6a. Staff Report - Master Street Plan Update - Comp. Plan Docket

PLANNING COMMISSION AGENDA ITEM CITY OF SHORELINE, WASHINGTON

AGENDA TITLE: 2017 Comprehensive Plan Amendment – Master Street Plan Update (Transportation Master Plan)
DEPARTMENT: Planning & Community Development
PRESENTED BY: Nora Daley-Peng, Senior Transportation Planner
Paul Cohen, Planning Manager
Steven Szafran, AICP, Senior Planner

Figure 3.3-14 Conceptual Cross Section for N-NE 185th Street

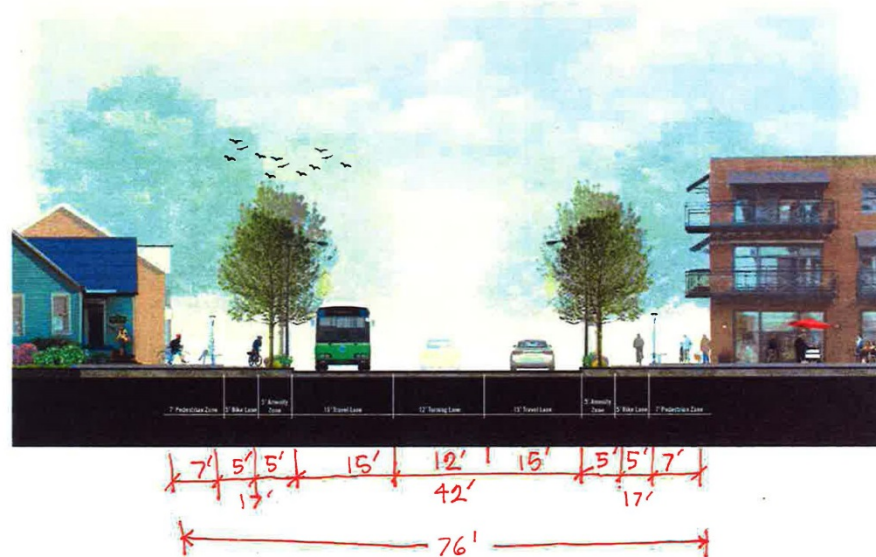
The following conceptual cross-section for the 185th Street corridor was developed in the 185th Street Station Subarea Plan based on the projected land use and transportation needs. However, the corridor needs to go through additional design development, and traffic and environmental analysis in order to take this early concept into a plan for implementation.

The above conceptual cross section for motorized travel does fit the 185th Street roadway improvements within the current Master Street Plan's *curb-to-curb* width of 42'. However, it exceeds the Master Street Plan's overall 66' *cross-section* which includes non-motorized improvements by 10'. The extra 10' is proposed in an effort to achieve "Transit-Oriented Community" goals and policies, which encourage mixed-use

The following proposed amendment will amend the TMP's Master Street Plan to include the consideration of the 185th Street Multimodal Corridor Strategy when determining required right-of-way and planned curb-to-curb width along 185th Street. In addition, the proposed amendments would remove language that currently exempts the 185th Street Bridge over I-5 from required amenity zones.

Functional Classification Minor Arterial	Street	From	To	Total Existing Right-of-Way	Existing Curb-to-Curb Width	Required Right-of-Way	Planned Curb-to-Curb Width	Notes
Minor Arterial	N 185 th St	Aurora Ave N 140 feet west of Aurora Ave N	Aurora Ave N	60	42	As per the Aurora Corridor Project <u>and to be determined in conjunction with 185th Street Multimodal Corridor Strategy</u>		
Minor Arterial	N 185 th St	Aurora Ave N	Midvale Ave N	60	42	As per the Aurora Corridor Project <u>and to be determined in conjunction with 185th Street Multimodal Corridor Strategy</u>		
Minor Arterial	N 185 th St	1 st Ave NE	10 th Ave NE	60-260+	42	66	42	No amenity zones required across bridge
